**Evaluation of proposed move for Water Right Nos 41456 and 41725**

Proposed: Move water right nos. 41456 and 41725 a distance of 2,435 ft to the southeast.

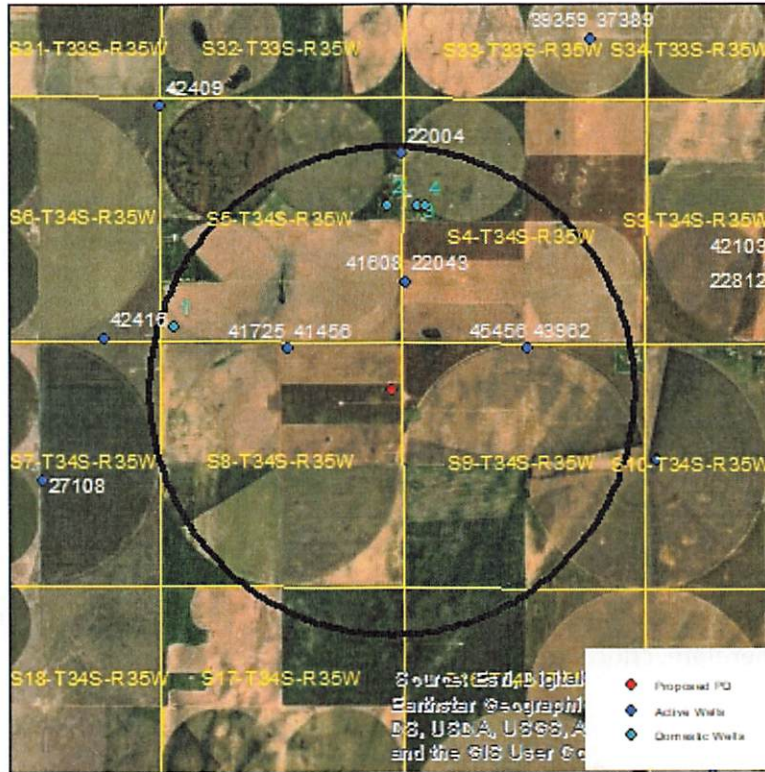
Wells within 1 mile: 22043 & 41608, 43962 & 45456, and 4 domestic wells, numbered on the above map.

The saturated thickness at the proposed well location is estimated to be 363 ft, based upon the GMD3 model. For saturated thickness greater than 200 ft, the drawdown allowance is 4.0 ft.

Net drawdown does not exceed the drawdown allowance of 4.0 ft for any wells within 1 mile of the proposed location. Therefore, critical well analysis is not necessary.

Based upon information from the GMD3 model, this proposal will cause minimal effects on neighboring wells, and is unlikely to create an impairment. GMD3 staff recommends approval of the application.

WELL TEST ANALYSIS

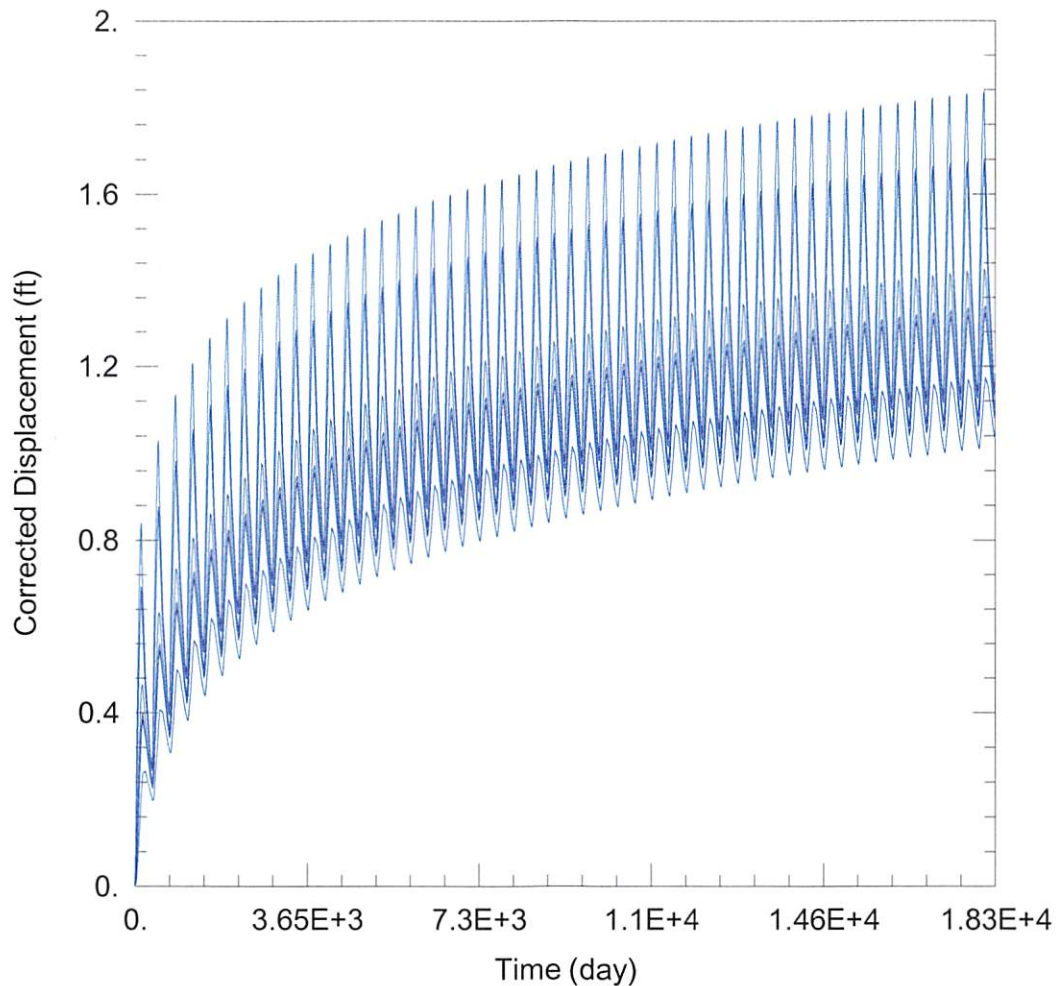
22043 & 41608:	Drawdown from current location = 1.68 ft
	Drawdown from proposed location = 3.83 ft
	Net drawdown = **2.2 ft**
43962 & 45456:	Drawdown from current location = 1.17 ft
	Drawdown from proposed location = 3.33 ft
	Net drawdown = **2.2 ft**
